Docket Items # 2 BAR CASE # 2010-0149

ISSUE: Alterations

LOCATION: 227 South Fairfax Street

STAFF RECOMMENDATION: Staff recommends approval of the Certificate of Appropriateness, as submitted.

Figure 2: Proposed Front Elevation

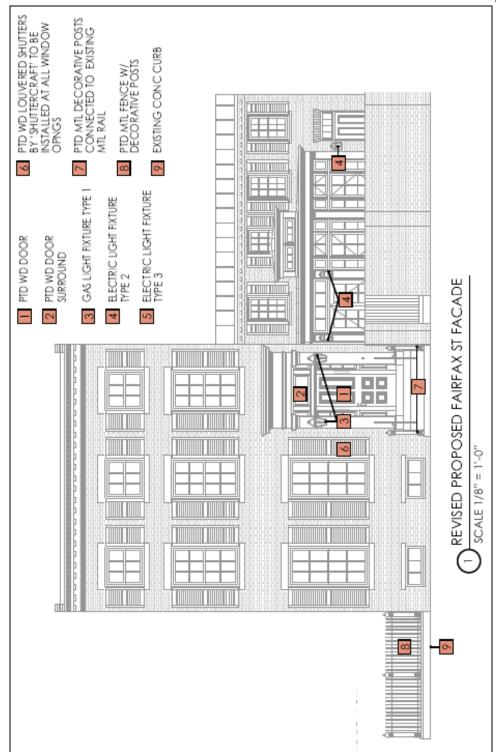
The applicant is requesting the installation of wood, paneled louvered shutters on the subject property. The each set of shutters will be sized to fit the size and shape of the window opening. After a site visit, the current physical evidence of existing shutter hinges on the window frames suggests that historically all of the building's existing windows had shutters. Since the subject proposal will be replacing missing documented features with appropriately sized operable, wood louvered shutters, the subject proposal is in compliance with the *Design Guidelines*.

Figure 5: Proposed Fence Detail

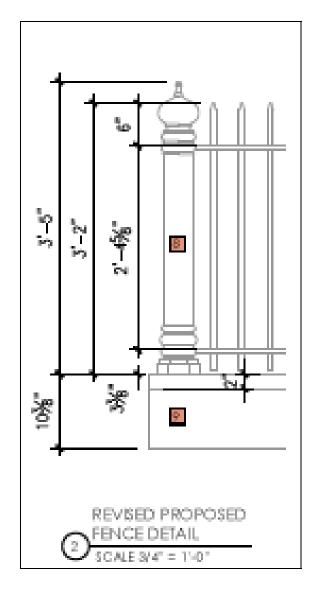
The design of proposed fence is compatible in style and massing to the historic house, and conforms to the *Design Guidelines* for fences. In keeping with the recommendations contained in the *Guidelines*, the fence serves as a distinctive feature of the streetscape "which should be appropriate in materials, design and scale to the period and character of the structure they surround." The applicant originally gained approval from the Board for the construction of wood 3-1/2 foot high, pyramidal picket fence to enclose the southern courtyard. This fence design was modeled after

photo documentation of the house during the late 1960s. The current proposal is a 3.5' high, painted iron fence with decorative posts. The applicant is utilizing a local foundry which casts new fence posts from original Greek revival artifacts. Although there is photo documentation of a wood fence, a metal fence would have been a common architectural feature for a high-style Greek revival house and Staff supports this requested change.

Figure 6: Proposed Light Fixtures

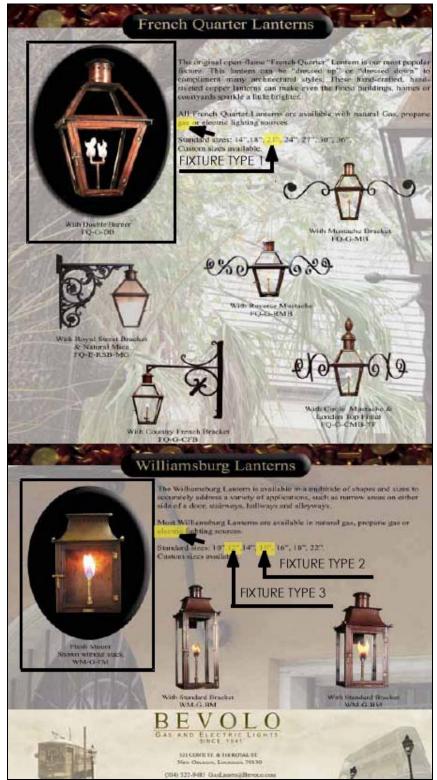
New lighting is being proposed on the front and side garden entrances (see drawing on page 7). The *Design Guidelines* stipulate that "the color of the light should be appropriate to the architectural character of the building" and the "materials of the light fixtures should be appropriate to the structure." The front Greek revival entry will be lit with copper gas lanterns and the new conservatory and side garden entry with electric copper lanterns. The design, materials and locations of these lanterns are appropriate to the architecture of the house and meet the standards outlined in the *Design Guidelines*.
